APPLICATION NO.	FILING DATE	FIRST NAMED INVENTOR	ATTORNEY DOCKET NO.	CONFIRMATION NO.		
10/811,235 03/26/2004		Mario Spatafora	U 015109-7	9021		
140 7.	590 07/12/2006		EXAMINER			
LADAS & PA		KIM, SANG K				
26 WEST 61ST NEW YORK,	-	ART UNIT	PAPER NUMBER			
1.2 2.2.2.3			3654			
		DATE MAILED: 07/12/2006

Application No.		Applicant(s)			
Office Action Summary		10/811,235		SPATAFORA, MARIO				
		Examiner		Art Unit				
			SANG KIM		3654			
Period fo	The MAILING DATE of this commun or Reply	ication app	ears on the cover s	heet with the co	orrespondence ad	ddress		
WHIC - Exte after - If NC - Failu Any	ORTENED STATUTORY PERIOD F CHEVER IS LONGER, FROM THE M nsions of time may be available under the provisions SIX (6) MONTHS from the mailing date of this comm o period for reply is specified above, the maximum st re to reply within the set or extended period for reply reply received by the Office later than three months and patent term adjustment. See 37 CFR 1.704(b).	MAILING DA s of 37 CFR 1.13 nunication. atutory period w will, by statute,	ATE OF THIS CON 6(a). In no event, howeve ill apply and will expire SIX cause the application to be	MMUNICATION ir, may a reply be time ((6) MONTHS

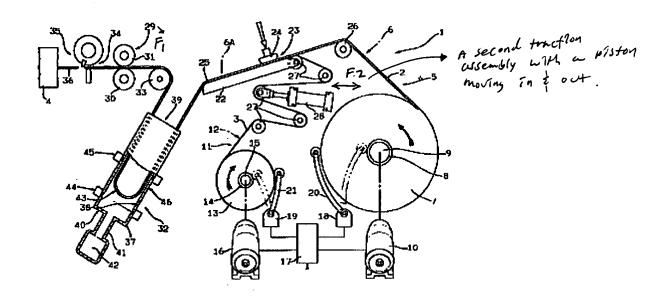
With respect to claim 1, EP '149 shows a device for feeding a continuous strip 2, a tear ribbon 3, a user machine 4, two reels 1, 13 with shafts 9, 15, first and second guides 26, 27 with respective paths 6, 12, a joining station 23 to form a composite strip 25, a traction assembly 29 to transmit a first pulling force (see illustration below, F1) and a second pulling force (see illustration below, F2) using a second traction assembly 27, 28 arranged between the reel 13 for the tear ribbon and the jointing station 23, on a

portion of the tear ribbon extending between its respective said reel 13 and the joining station 23, see illustration below.

Applicant's arguments filed on 6/9/06 have been fully considered but they are not persuasive with respect to claims 1-10. The drawing illustrated above is to show the applicant which element is considered to be a second traction assembly.

Examiner agrees with the applicant that the EP '149 device uses the actuator 28 with respective diverting roller 27 to vary the length of path with substantially no tension being applied to tear strip. However, the examiner disagrees with the applicant's assessment that the EP '149 device using the actuator 28 with respective diverting roller 27 cannot be considered as a second traction assembly.

The reference EP '149 uses the actuator 28 to vary the length of path to the tear strip by actuating the piston in and out. A second force is generated by moving the piston in and out, causing the web to vary the length as it goes into the joining station, thus, the actuator 28 with the roller 27 can be considered as a second traction assembly which can exert a force onto the web.
